AFFIDAVIT

My name is Richard D. Parks. I work as an investigator for the Government Accountability Project (GAP) in the Diablo Canyon Power Plant (DCPP) Investigation. I am providing this sworn statement to evidence concerns over a problem at DCPP.

These documents relate to Residual Heat Removal (RHR) Pump #1 Recirculation Valve (FCV-641A- Unit 2), and its associated hanger #413-143 SL. On page 40 of Attachment 1, this valve is listed as being Environmentally Qualified. Attachment 1, pages 37-41 explain the significance of this qualification.

DC-2-E-P10544 RSL
SK. 413/1435L REV. CONTROLLED COPY (REF)

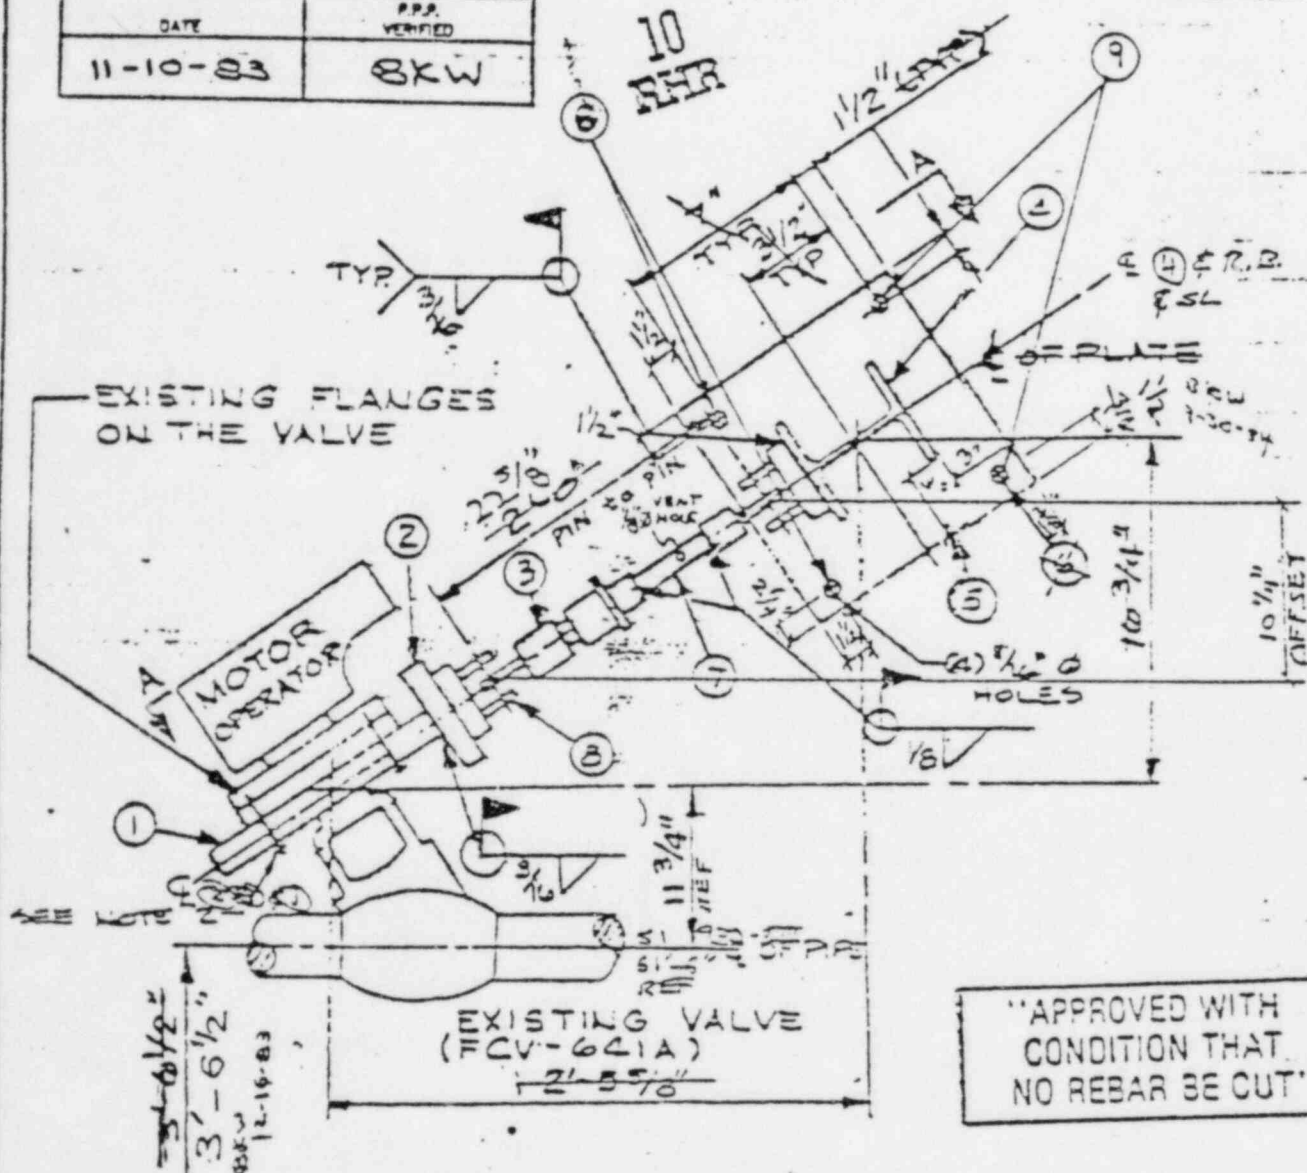
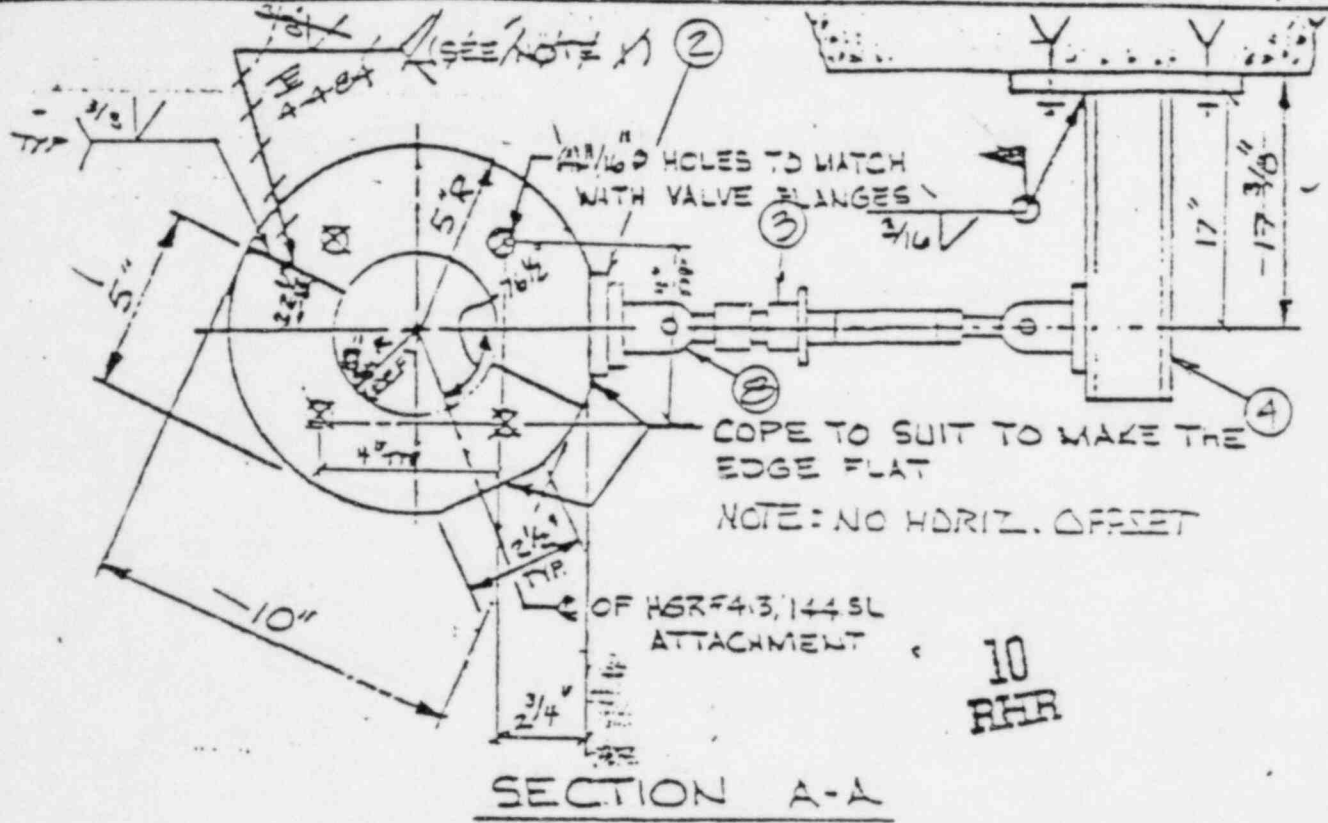
1. THE RING IS IN TWO HALVES AND IS TO BE WELDED ON UNDERSIDE AFTER BOLTING TO THE VALVE FLANGE
2. FIELD TO REPLACE EXISTING 5/8" Ø STUDS WITH LONGER STUDS OF SAME SPECIFICATION: ASTM A573 GR. 57

A-1
pg 9

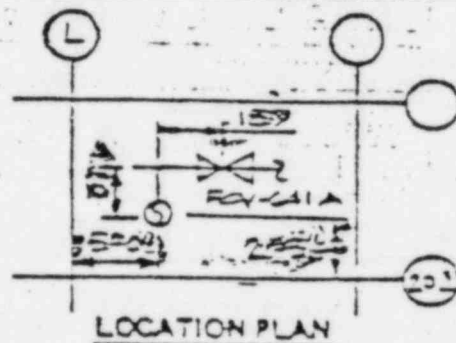
Problem #1: During the "As-built Inspection", the responsible QC Inspector identified that the 5/8" studs holding the valve motor to the seismic valve support plate (piece # 1, Attachment 1 page 9) had never been replaced. These studs were required to be changed by the original Design Change #DC-2-E-P-10544, (refer to Note #2 Attachment #1, page 7). This deficient condition was documented on a DCN (Attachment 1 page 16) and identified that a Deviation Report should be submitted to PG&E. This should have resolved the problem; however, the original inspector was over ridden and his DCN changed by A. Weinstein on 2/27/84. A. Weinstein's justification for his action is described on page 17 of Attachment 1.

PIPE SUPPORT DESIGN TOLERANCE CLARIFICATION FORM

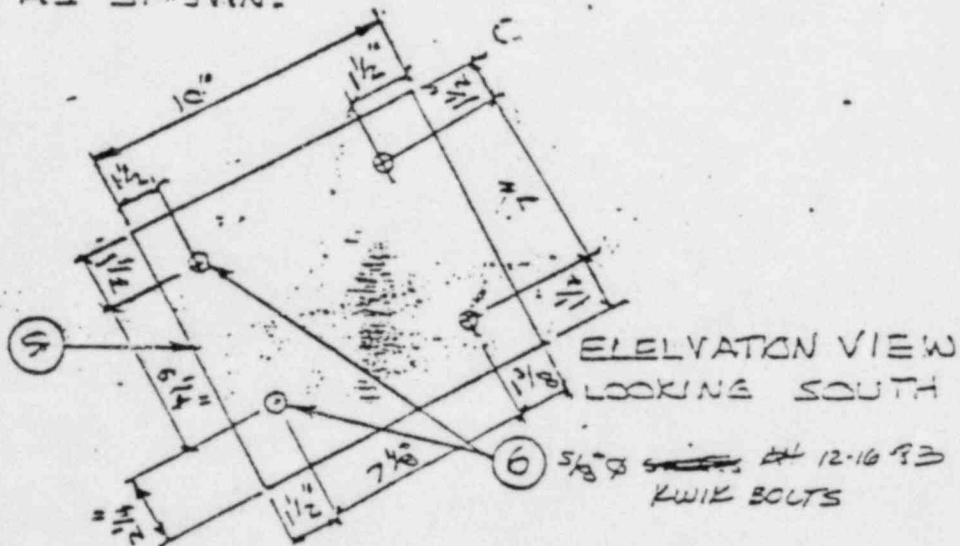
DESCRIPTION: BOLTHOLE LOCATION ON BASE R 5
AS SHOWN:

IS THIS ACCEPTABLE?

THIS IS ACCEPTABLE
